EN010125: Application by RWE Renewables UK Dogger Bank South (West) Limited and RWE Renewables UK Dogger Bank South (East) Limited for the Dogger Bank South Offshore Wind Farms Project

The Examining Authority's Written Questions and requests for further information

Issued on 28 February 2025

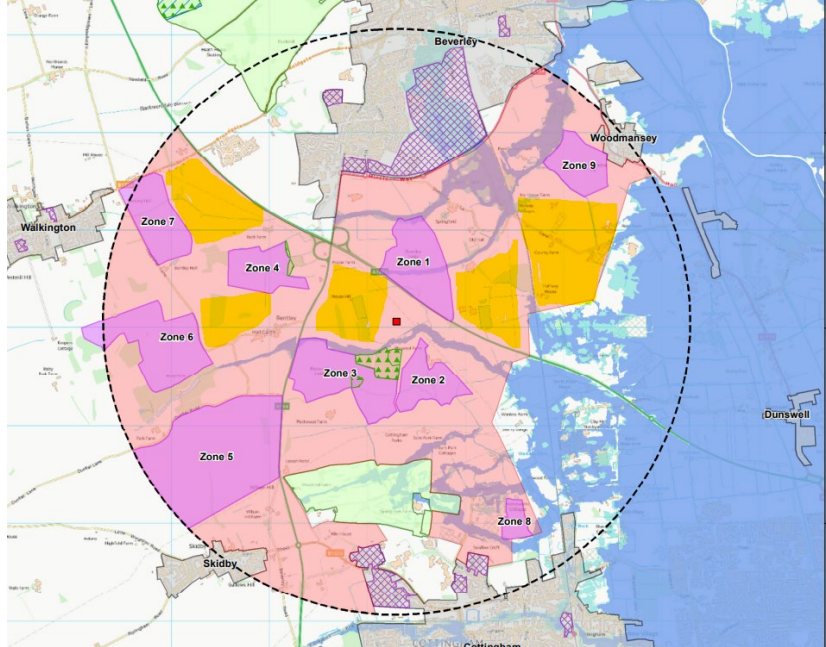
ExQ1	Question to:	Question
GD.1.3	The Applicants	<p>Converter station zone</p> <p>The DAS [REP2-027, paragraph 196] states that visual screening could be required where there may be receptors. Can you explain what you mean by 'visual screening' and indicate where this could be required? Paragraph 196 also suggests acoustic fencing might be required in specific locations. However, paragraph 203 appears to contradict this and states that no additional mitigation measures would be required due to negligible effects on receptors from noise. Can you clarify if and where acoustic fencing would be required? If it is required, can you provide details of its visual appearance, where it would be secured and - if it is not secured - should it be?</p>
GD.1.4	The Applicants	<p>Converter station zone</p> <p>The DAS [REP2-027, paragraph 210] assumes that planting hedges over the existing high-pressure gas pipelines would be acceptable, subject to consultation with the owners of these assets. What are the implications if consent from the owners to plant hedges over the high-pressure gas pipelines was not given? How would this affect the outline landscaping plans and what would be the effects on the landscape and visual assessment?</p>

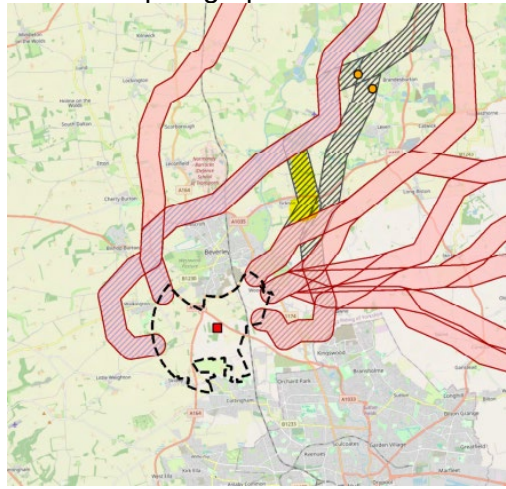
ExQ1	Question to:	Question
		utilised for transmission of electricity generated by the Proposed Development? Can you provide evidence to support your answer?
GD.1.10	ERYC and HCC	Site selection Do you consider that there are any additional sites that should have been considered in the Applicants' site selection and alternatives assessment [AS-017]? If so, can you set in detail why you consider this to be the case?
GD.1.11	The Applicants	Site selection ES Chapter 4 [AS-017, table 4-2] presents key stakeholder responses to site selection and the assessment of alternatives. Whilst table 4-2 does state that comments made by key stakeholders were taken account of, it does not say how. Can you set out what changes were made to site selection as a result of these consultation responses?
GD.1.12	The Applicants	Site selection – converter stations How was the initial 3km area of search radius for the location of a substation from Creyke Beck determined? ES Chapter 4 [AS-017, paragraph 16] confirms that you were informed of an updated location for the substation connection at Birkhill Wood. However, it appears that the area of search was not updated to focus on Birkhill Wood to determine the site selection process for the location of other elements of the Proposed Development (ie the cable route and converter stations). As the area of search was not updated once the location of connection at Birkhill Wood was provided, could there be alternative options for the location of the Proposed Development which had been initially discounted? If so, can you provide more details on the suitability of these options?

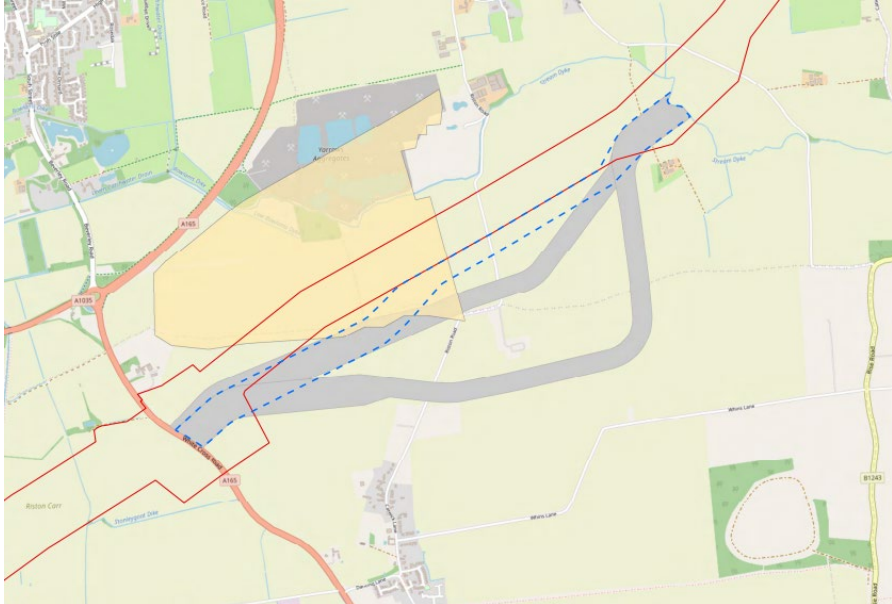
GD.1.13	The Applicants	Site selection – converter stations Why were the areas highlighted in orange below not included in the substation zone long list (map taken from [AS-011]):
